Regarding: Plans for Taylor Park

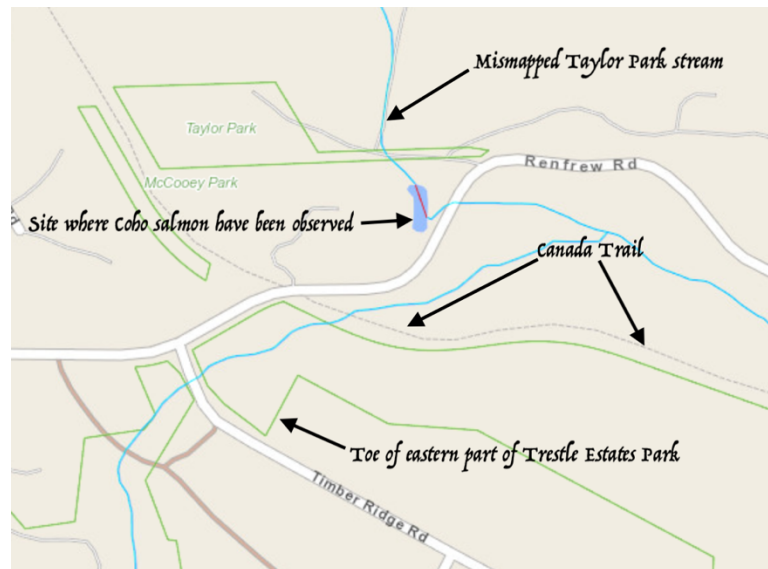
In a Board meeting of February 24, 2022, Mr Farquhar, Manager of the CVRD Parks and Trails, stated that there are no wetlands identified in Taylor Park as determined by a preliminary environmental consultation. I would suggest that Mr Farquhar should not have bothered with a consultant and simply walked the park himself; then, he would have clearly seen the stream that meanders back and forth within the lower two-thirds of Taylor Park – see adjacent photograph.

The Taylor Park meandering stream empties into a wetland and pond adjacent to Renfrew Road – see adjacent figure taken from iMapBC. Note the path of Taylor Park stream is shown incorrectly on iMapBC – it meanders through the bottom two-thirds of the park and does not cross the panhandle as shown on the map. After emptying into a pond the creek enters a culvert under the Renfrew Road and ultimately joins the West Arm Creek that empties into Shawnigan Lake. This area of Renfrew Road was washed out last fall with the heavy rains and at that time many Coho salmon were noted to be in the adjacent wetland. It is very possible that the Coho have spawned in the Taylor Park stream. The Taylor Park stream is classified as fish-bearing, whether or not fish are present in the stream, since the stream ultimately enters fish-bearing waters. The Shawnigan Basin Society will investigate later in the spring to determine whether there are Coho fry in the Park's stream.

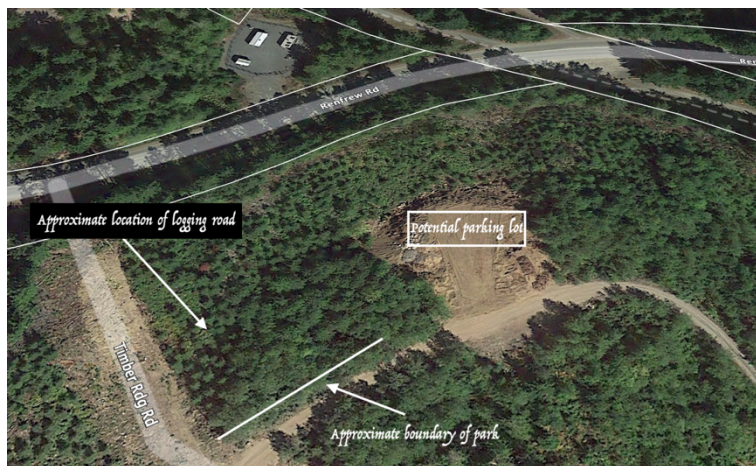
The toe of the eastern part of this park (see previous figure) might make a suitable parking lot. A Google Earth image of the toe of the eastern part of Trestle Estates is shown to the right. The toe is at two elevations: the northern third is at a lower elevation (~144 m above sea level) and has a stream running through it as can be seen on the map in the previous page. This stream joins the Taylor Park stream to form the West Arm Creek.

The southern part of the toe is at an elevation of ~155 m above sea level with a steep bank separating the two components.

Coming off Timber Ridge Road there is an old road, possibly originally a logging road, going into the southern part of the toe that leads to a large relatively flat cleared area. This road could be readily expanded to allow two-way traffic and the large clear area could easily be turned into a parking lot. To prevent 6PPD released from tires to enter the stream on the lower northern third of the toe, one should have a berm around the eastern, northern and western part of the parking lot to ensure that water from the parking lot does not flow over the slope to enter the stream.

Furthermore, a rock-filled water collection pit should be built in the centre of the parking lot to receive water from the parking lot. Micro-organisms in this collection basin could then metabolize the 6PPD and 6PPD-quinone compounds to innocuous compounds.
